Draft of a letter to be sent to DEP, EPA, SRWMD, and Bradford County

Based on the information in the documents we found in OCULUS, the Bradford Soil and Water Conservation District (BSWCD) has several concerns about the operation of the Chemours Trail Ridge South (TRS) Mine on Suwannee River Water Management District (SRWMD) property in Bradford County. The BSWCD believes that answers to the questions ask in this document will reduce the chances of environmental impacts from the operation of the Chemours TRS Mine in the future. The documents being referenced are in bold type.

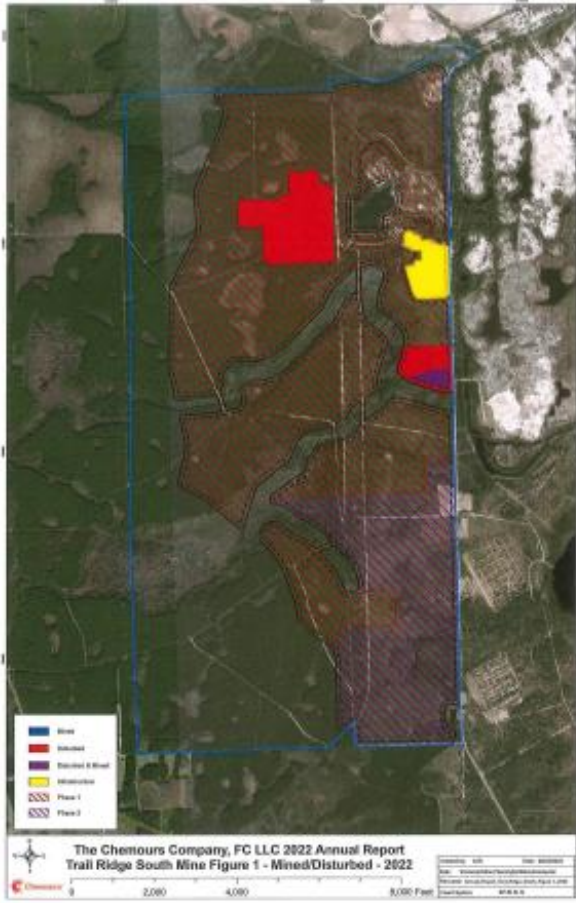
How deep was the pit?

What is the area of the pit?

What is the status of the stockpiled sand?

Did the pit receive water with radium levels of 9.3 piC/L noted in the radium exceedance documents?

What was/is the radium levels of the tailings?

Should the pre-dig pit area be shown as mined?

Should the pre-dig pit area in tan in the image on the right be shown as mined in the image on the left?

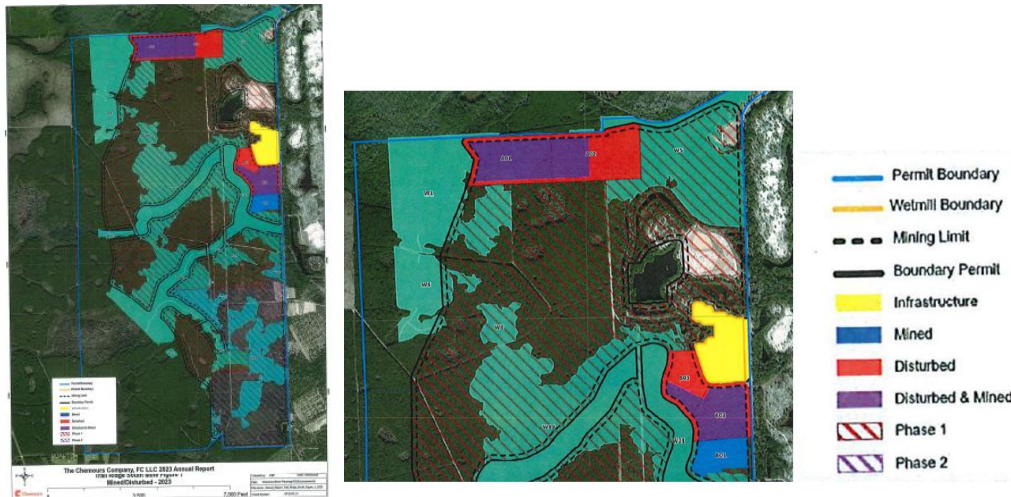
Where can the enclosures be found on OCULUS?

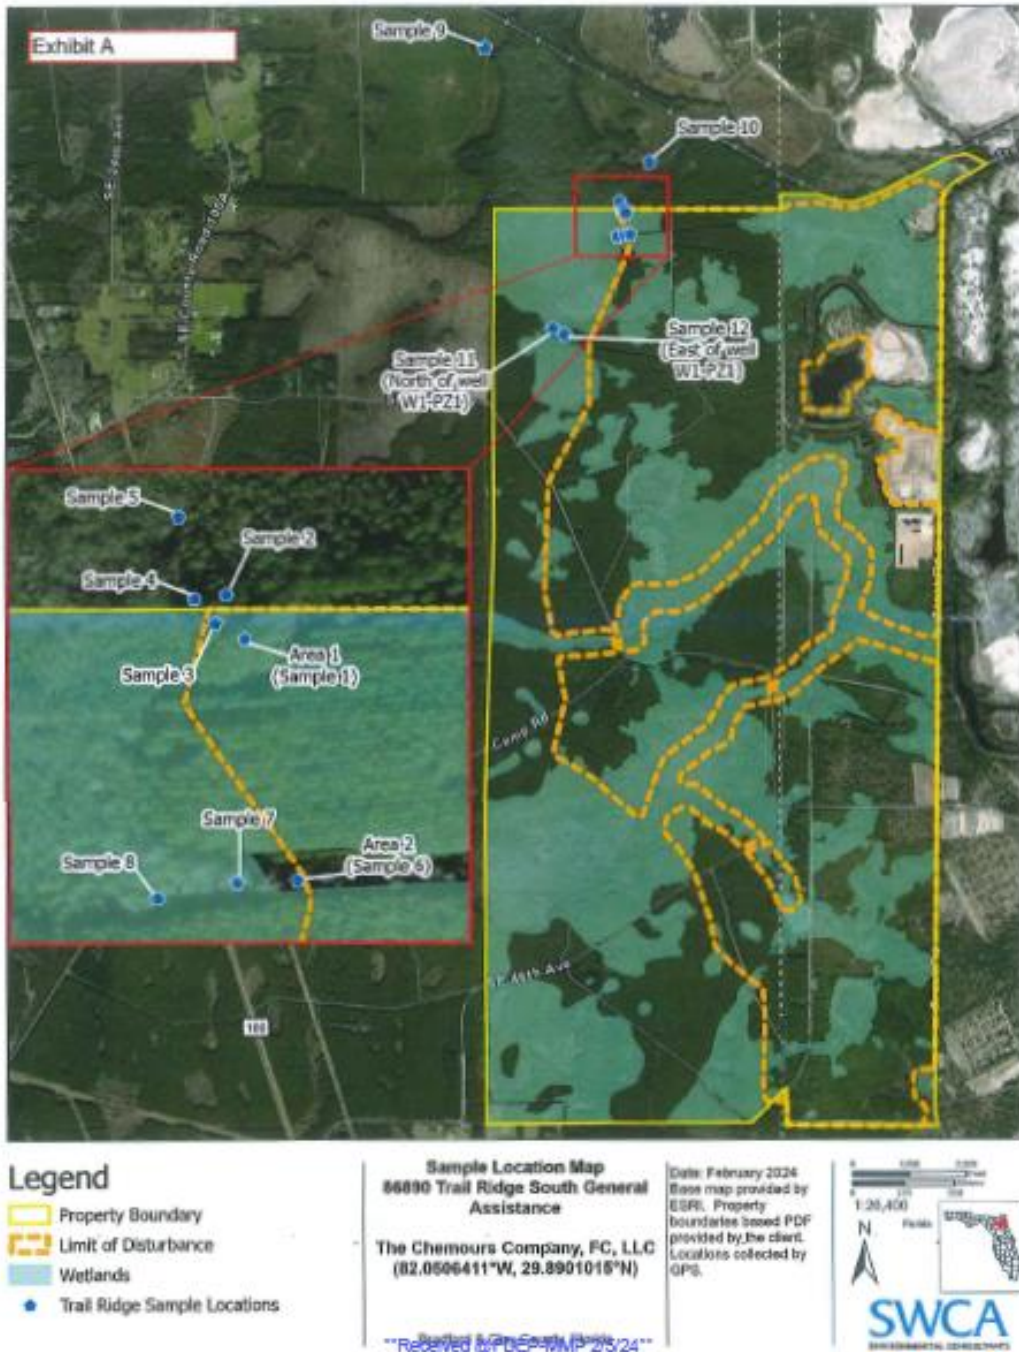
What data was used to establish that “there was no sediment deposition within the offsite wetlands”?

What is the grey material seen under the water in the image from page 8 of the **Trail Ridge South Release Incident NO. 20024-0997 5 day Report**

Are Sample 2 and Sample 4 on NFLT property?

Why is the location of the berm breach not shown on the image?

Why is the location of the berm overtopping not shown on the image?  
Where is the mine cell pit that was receiving the process pond water?  
Did the process water contain tailings?  
What was the concentration of the tailings in the process pond water?

Northwest Corner Reclamation cell – Where water entered wetland  
(January 31, 2024)

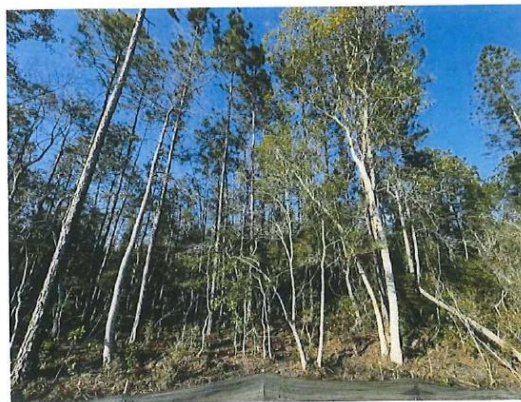
Why were GPS coordinates and direction not provided for the above images?
